CITY OF OREGON CITY HISTORIC REVIEW BOARD AGENDA

1. GLUA-21-00038 and HR 21-000016: Historic Review for solar panel installation on the Joseph and Bertha Kuerten House at 815 Monroe St.
2. GLUA-21-00039 and HR 21-00017: Historic Review for new construction of a single dwelling on a historic Landmark site - the Rasmussen-Hadley House at 412 Logus Street.
3. GLUA 21-00042 / HR-21-00018: Revision to HR 19-04 for a new single dwelling in the Canemah National Register District at 306 4th Avenue
4. GLUA 21-00043 / HR-21-00019: Historic Review for Alteration of a Designated Structure in the McLoughlin Conservation District – the I.O.O.F. Hall at 602 7th Street

GLUA-21-00038 and HR 21-000016: Historic Review for solar panel installation on the Joseph and Bertha Kuerten House at 815 Monroe St.

REQUEST: Historic Review for solar panel installation on street-facing roof planes on a designated structure in the McLoughlin Conservation district, the Joseph and Bertha Kuerten House

PROPERTY PLAN

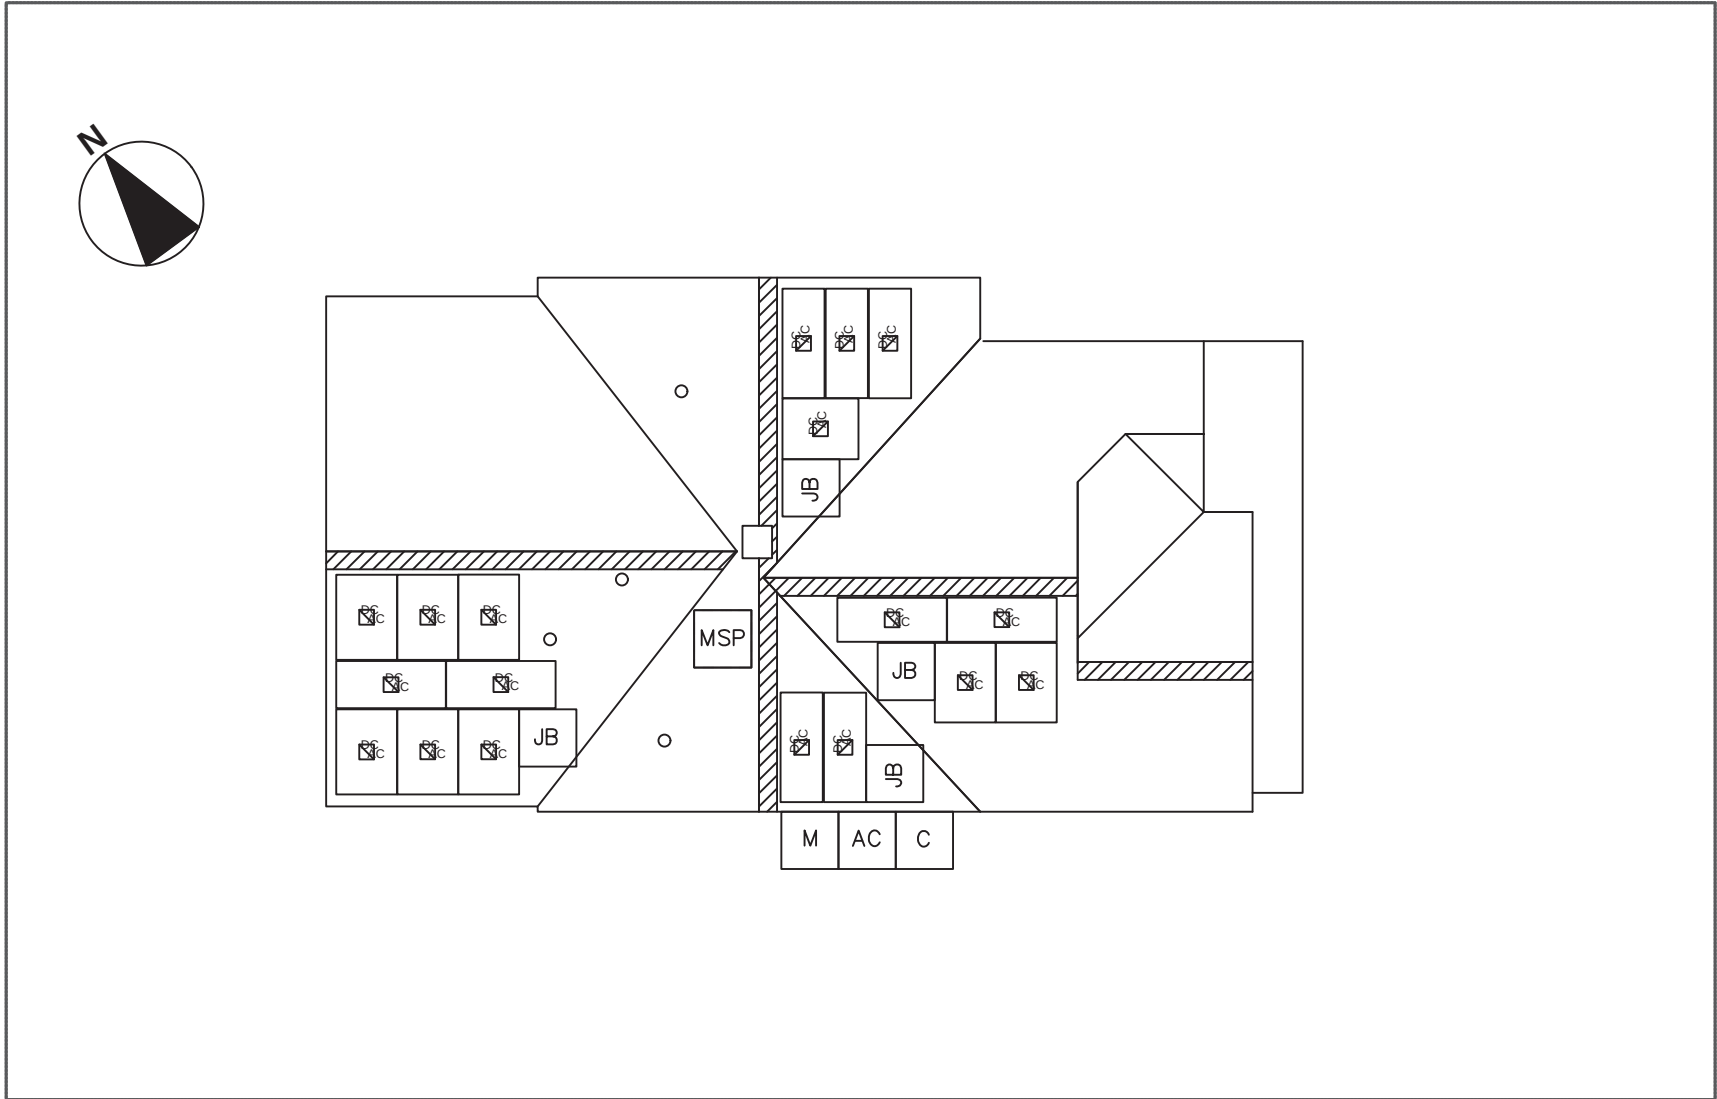
Staff finds that of the panels on roof plane D, which are on a rear-facing roof plane will not impact this historic integrity of the house. The panels on roof planes B and C are not visible when viewing the house straight on, even from the other side of the street, but they will be visible when looking at the house at an angle. The most prominent area, arguably, is roof plane A, which is visible from 9th Street and partially visible when looking at the house straight on from Monroe Street. If the Board finds that these panels will impact this historic integrity of the home, these panels may be mitigated by limiting the number of panels on the roof plane, or by avoiding that particular roof plane entirely.

The roof on the Kuerten House is a medium grayish composition shingle; so the panels will contrast moderately. The panels proposed on the roof planes A, B, and C will be visible from the right of way. The panels would not alter the pitch of the roof, but would change the appearance of the roof and would be visible from the street.

Staff recommends approval of the panels on roof plane D which are on a rear-facing roof plane. The panels on roof planes B and C are not visible when viewing the house straight on, even from the other side of the street, but they will be visible when looking at the house at an angle. The most prominent area, arguably, is roof plane A, which is visible from 9th Street and partially visible when looking at the house straight on from Monroe Street. If the Board finds that these panels will impact this historic integrity of the home, these panels may be mitigated by limiting the number of panels on the roof plane, or by avoiding that particular roof plane entirely.

Staff Recommends approval with conditions.

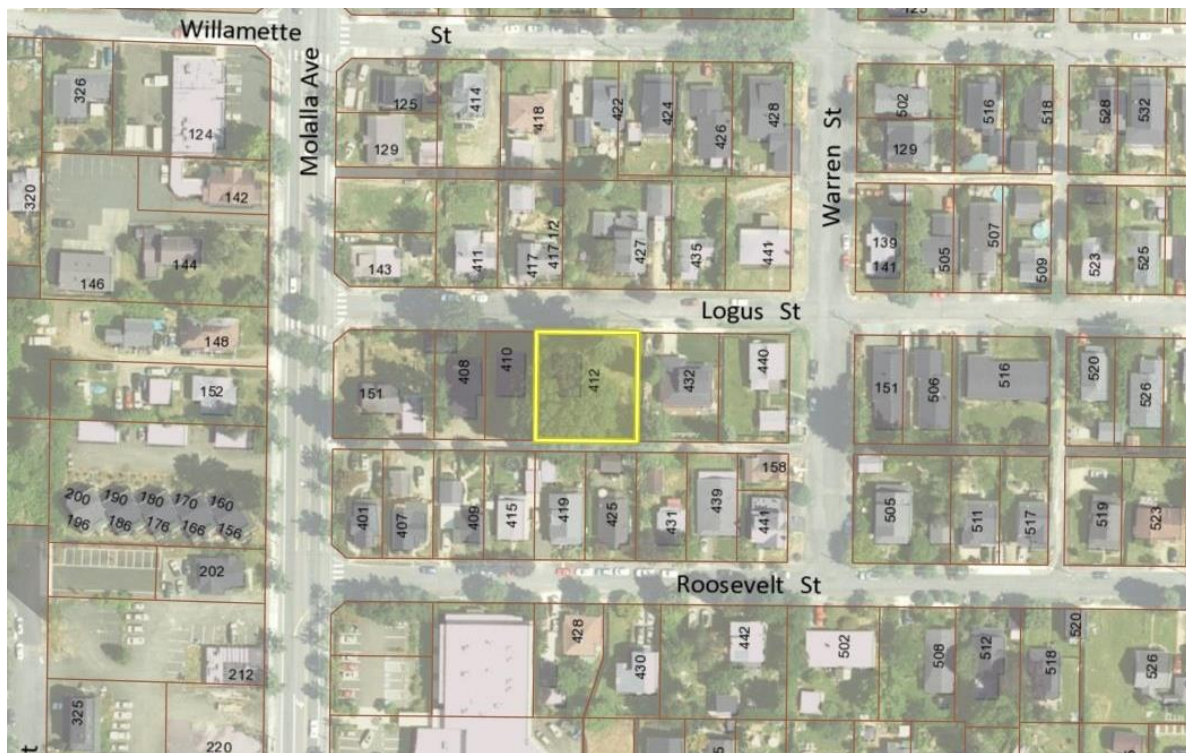
1. The pitch of the porch roof shall be reduced to 3- to 4:12, increasing the length of the top of the hip.
2. Windows on the front of the home shall be 1:1 double-hung with no grids or muntins.
3. The porch scrollwork shall be excluded.
4. Corner trim shall be utilized on the home.
5. The windows on the upper story shall be rectangular windows of 2 to 1 height to width proportion, symmetrically spaced.
6. The siding shall be smooth fiber cement or wood.
7. Incised lumber or pressure treated wood shall not be used on any visible surfaces.
8. The window sash shall be the darkest color of the three color paint scheme.
9. Porch railing, decking and posts shall be painted to match a color on the house.
